SERVICE BULLETIN

#0023

SUBJECT: Incorrect Nose Gear Bolt Replacement

Figure 1: Correct Nose Gear Bolt thread length

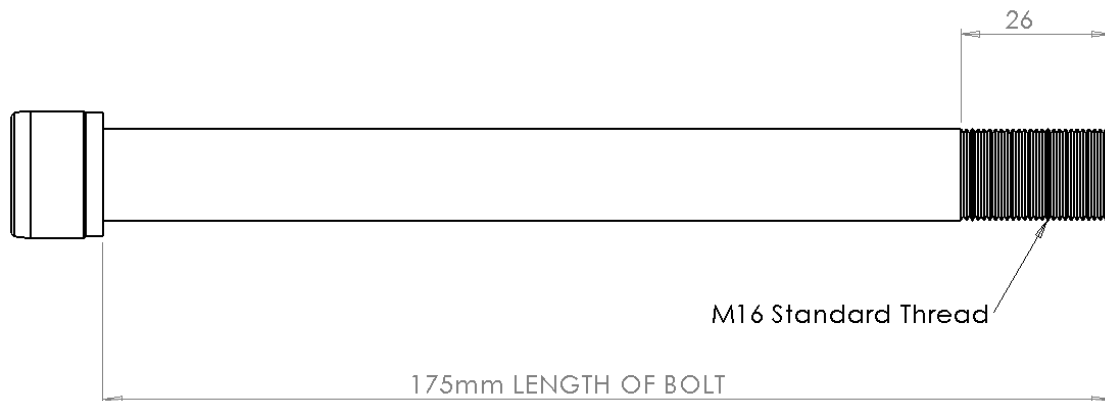
The threaded section on the nose gear bolt provided to the affected aircraft is too long. This results in the threaded section of the bolt being loaded and may make the bolt more likely to fatigue and/or possibly break with a rough landing. This bolt needs to be replaced with one of the correct thread length to ensure that the thread does not get loaded.

Figure 1 shows the correct nose gear bolt dimensions. The nose gear bolt (HW-MCB-612-X-X-0) dimensions should be checked and if the bolt's thread length is incorrect it must be replaced with a new bolt of the correct dimensions. These bolts can be ordered from Sling Aircraft.

Figure 4: Nose gear wheel assembly

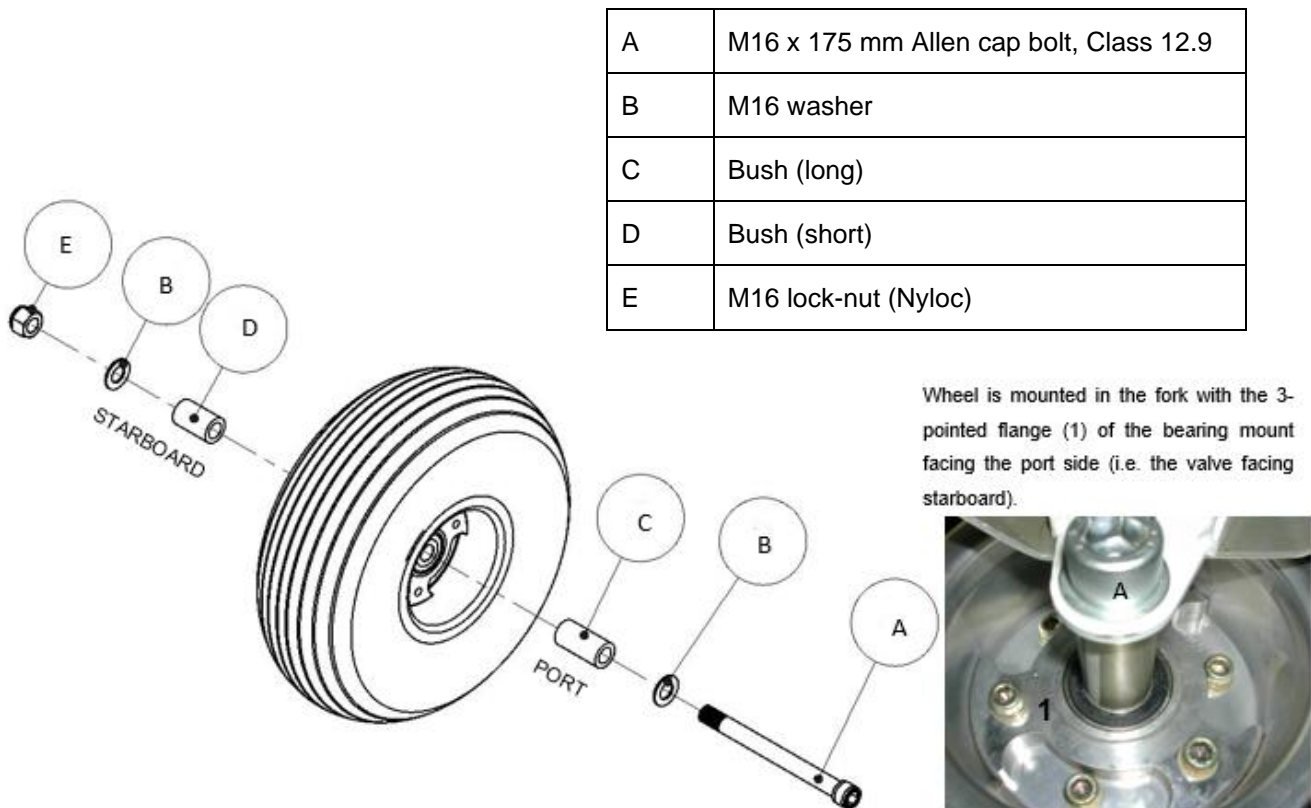
Step 1: In order to install the new replacement bolt with the correct thread length, reverse the procedure specified in Section 3.1. Ensure that the assembly of the wheel get reassembled correctly. Refer to the exploded view of the wheel axle assembly to ensure the components get placed in the correct positions, refer to Figure 4.

- Step 2: Torque the M10 Allen cap bolt to 10.5 Nm.
- Step 3: Apply torque seal into the bolt.
- Step 4: Verify free rotation for the wheel.
- Step 5: Apply Loctite 222 to the failing screws and reinstall the nose gear fairing.
